Staff Report

To: Salt Lake City Planning Commission
From: Daniel Echeverria, 801-535-7165, daniel.echeverria@slcgov.com
Date: September 7, 2021 (publication)
Re: PLNPCM2021-00524 Gabbott's Row Planned Development

Planned Development

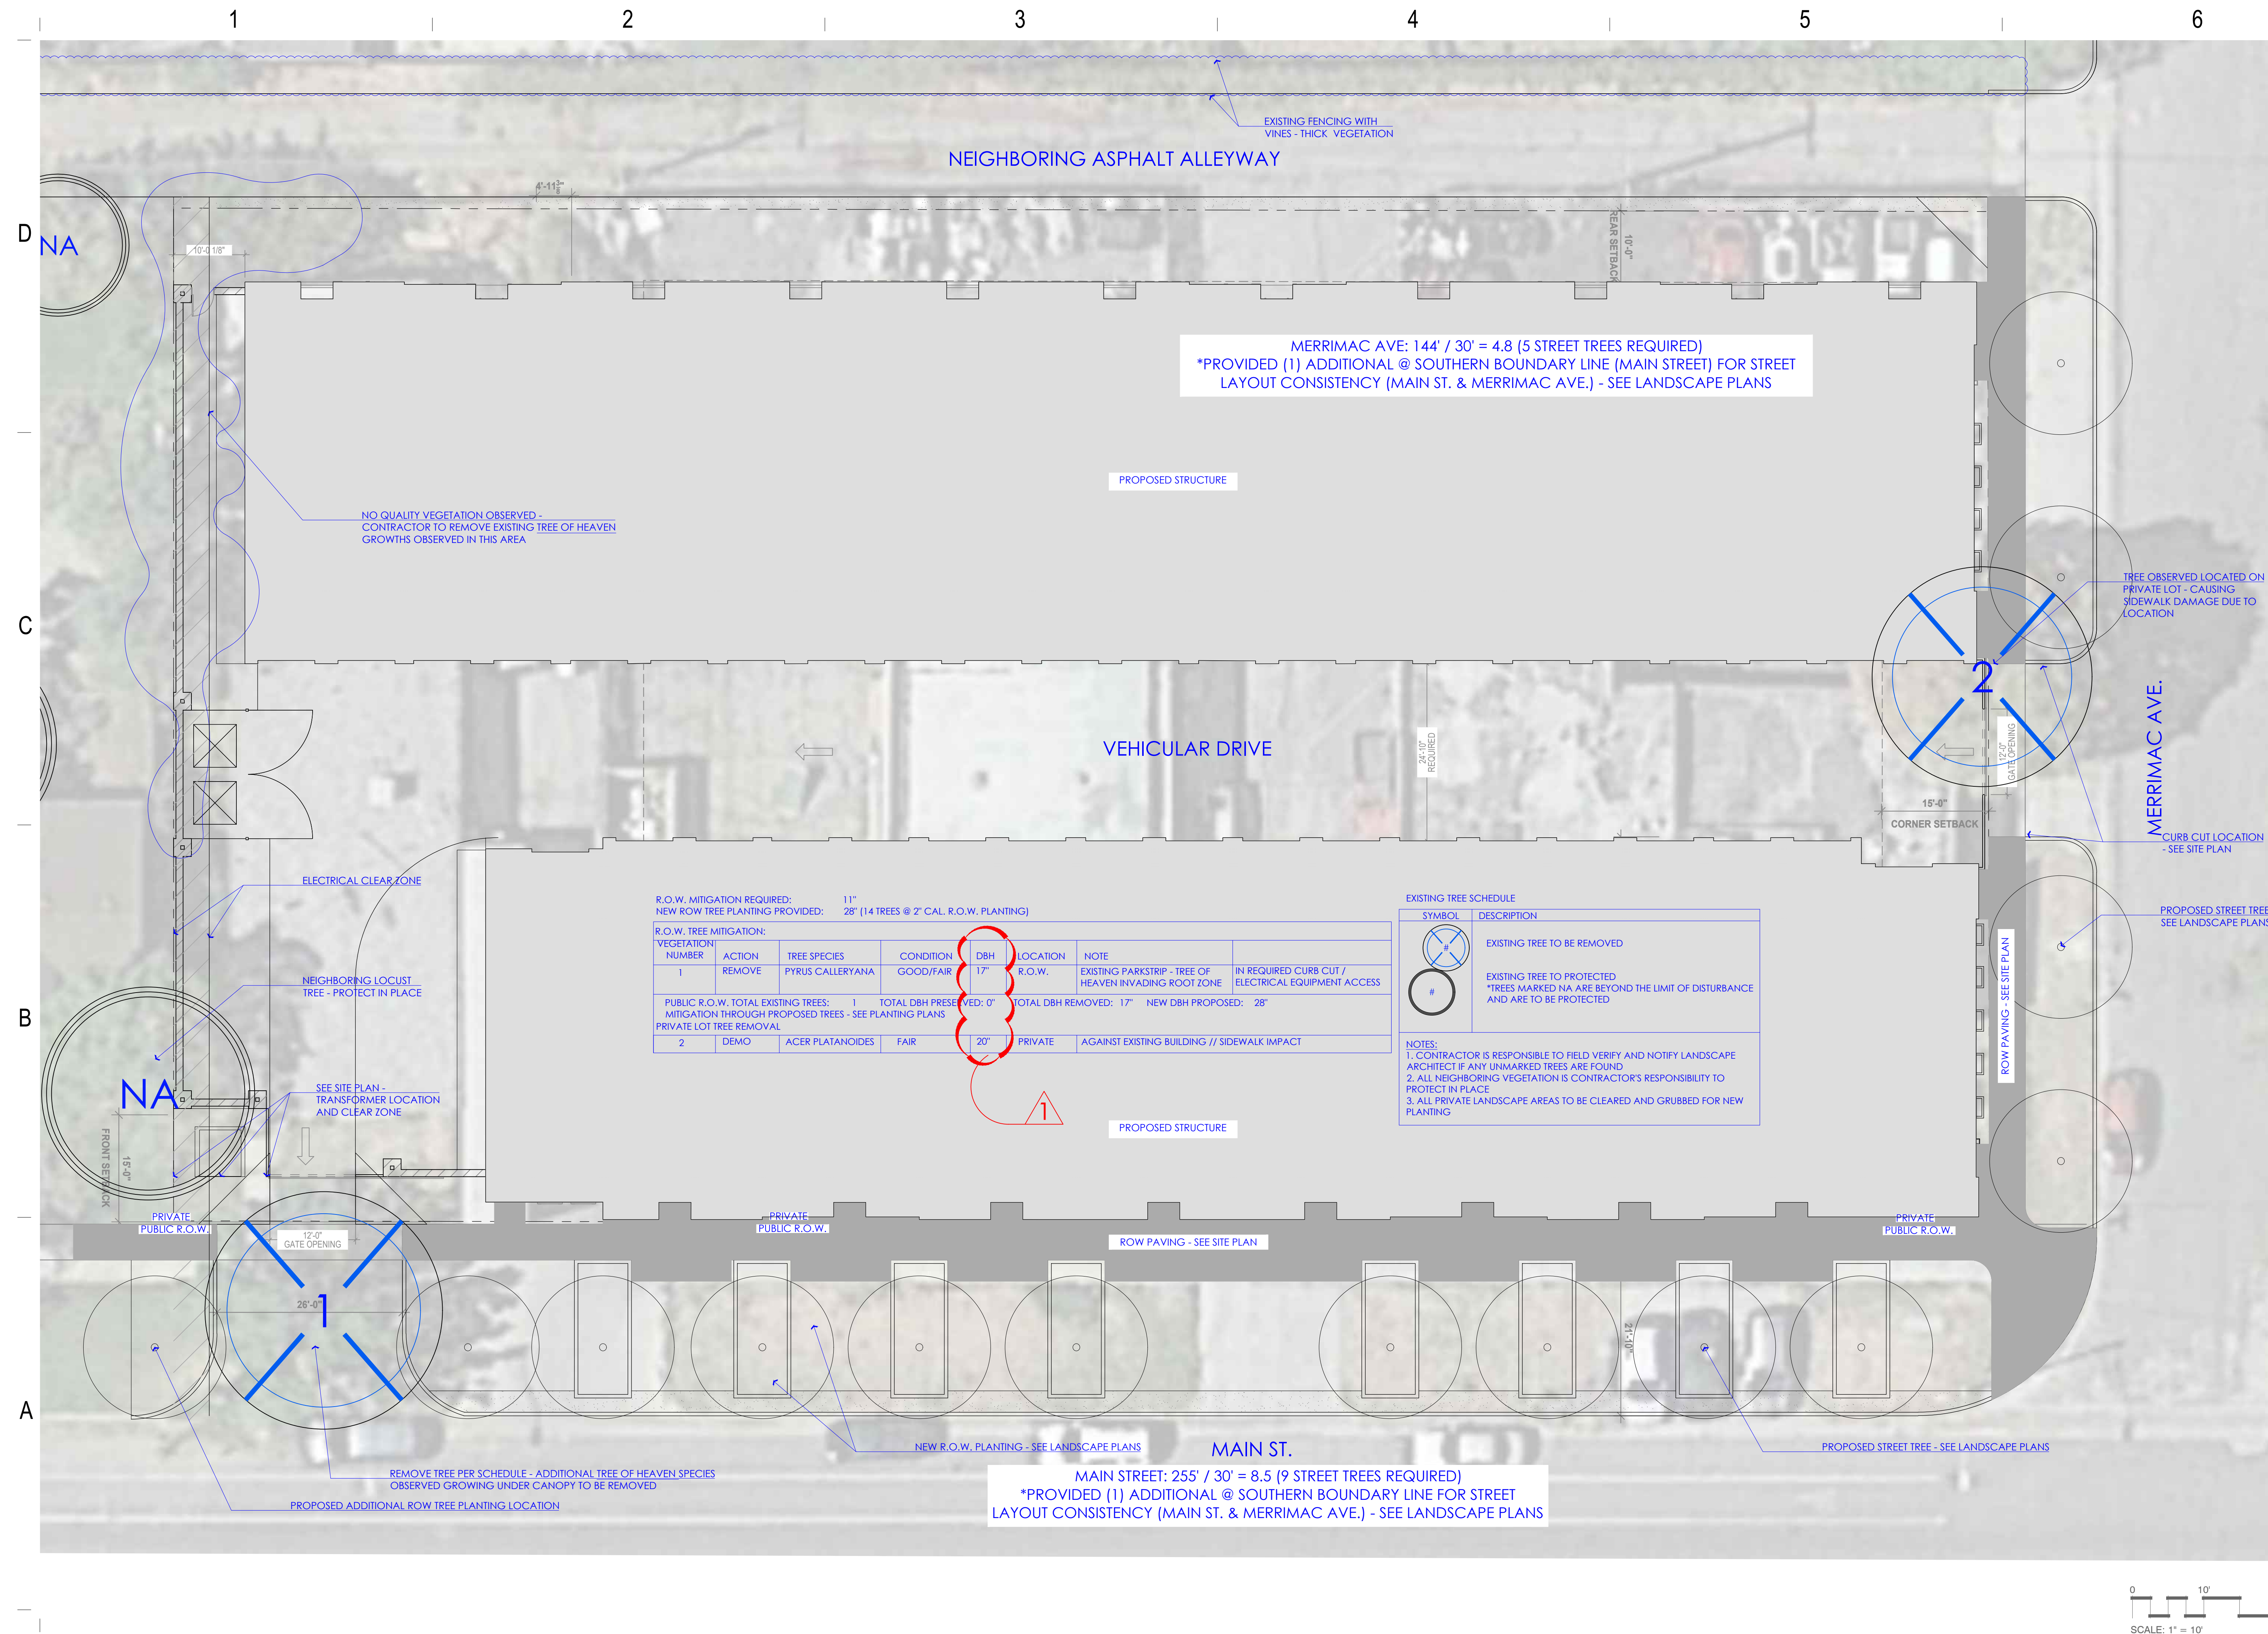
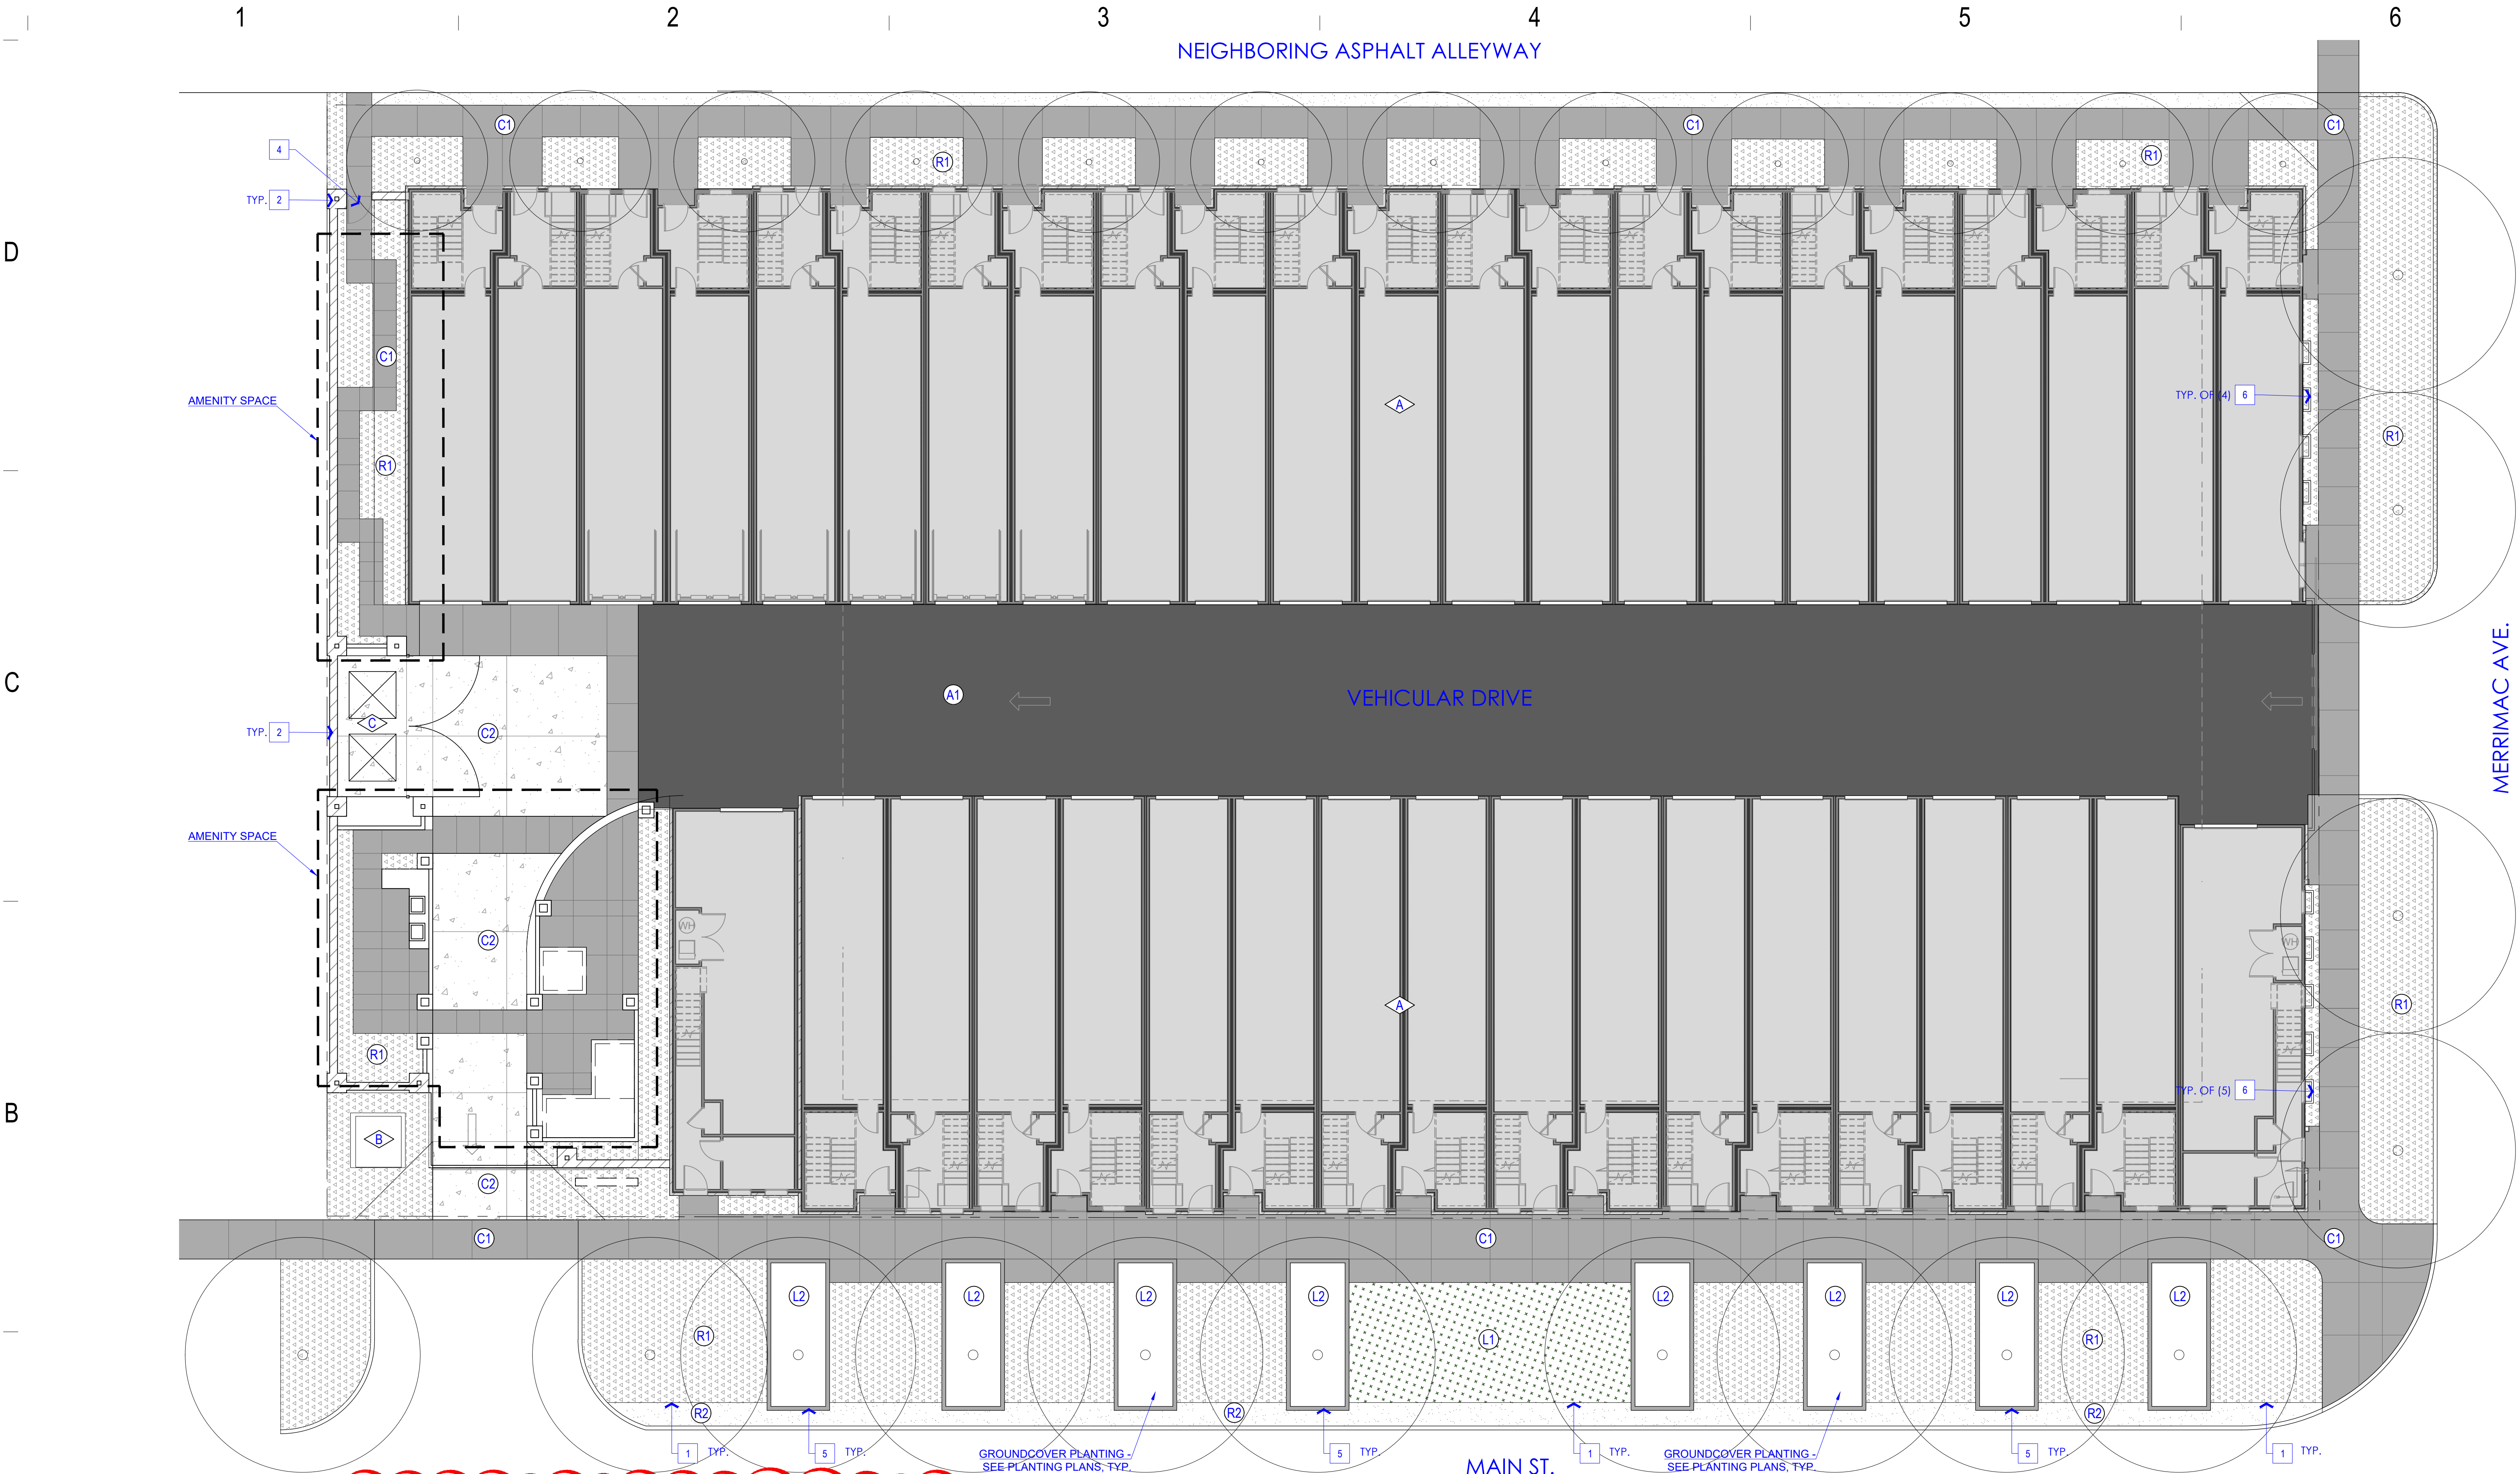
The 2" water meter as shown does not meet standards because it is directly over sewer and communication lines. The vault needs to be 5 feet from the sewer and 3 feet from the communications and any other utility lines. I also don't see power or gas on this plan in main street. There also needs to be 3 feet of pipe before and after the meter box before connections or turns. Dimensions need to be provided in the plan.

Planning Staff Note: The above are preliminary comments from public utilities regarding the proposed utility lines. There were concerns from Public Utilities that the reduced setback may limit the ability to adequately provide the private utility connections. The applicant will need to resolve all utility concerns prior to building permit issuance.
